Bulletin No: B407CRM155-0
 Release Date: April 3, 2008
 Effective Date: April 3, 2008
 Supersedes: N / A
 Completion Date: June 3, 2008
 Page: 1 of 3

SERVICE BULLETIN

Ride Name: PHARAOH'S FURY

Lap Bar Mounting Bolt Installation and Inspection

Installation Detail of LOCKING WASHER SET

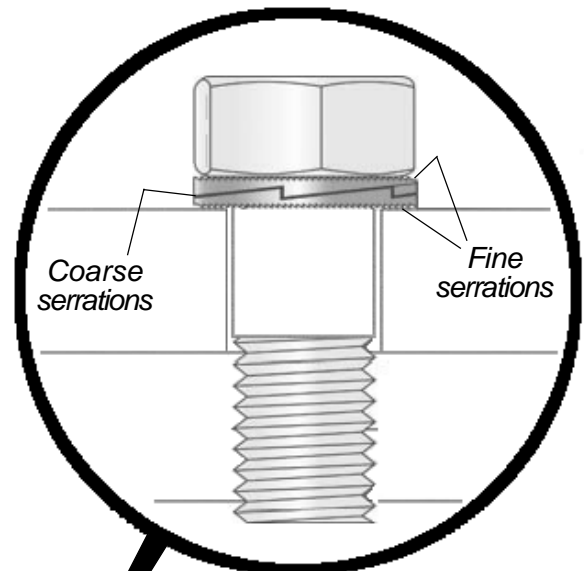
These washers must be installed in pairs. Make sure the coarse serrations of the two washers are mated with each other as shown. The fine serrations must be against the capscrew head and the mounting base.

Discard existing capscrew. Replace with new Hex Head Capscrew - 3/8-16 x 2-3/4" (part number 60768000) Tighten to 19 to 24 ft-lbs.

Discard existing split lockwasher. Replace with LOCKING WASHER SET, which consists of two special washers, installed exactly as shown in the detail (part number 228538803)

Inspect threads for damage inside lap bar mount
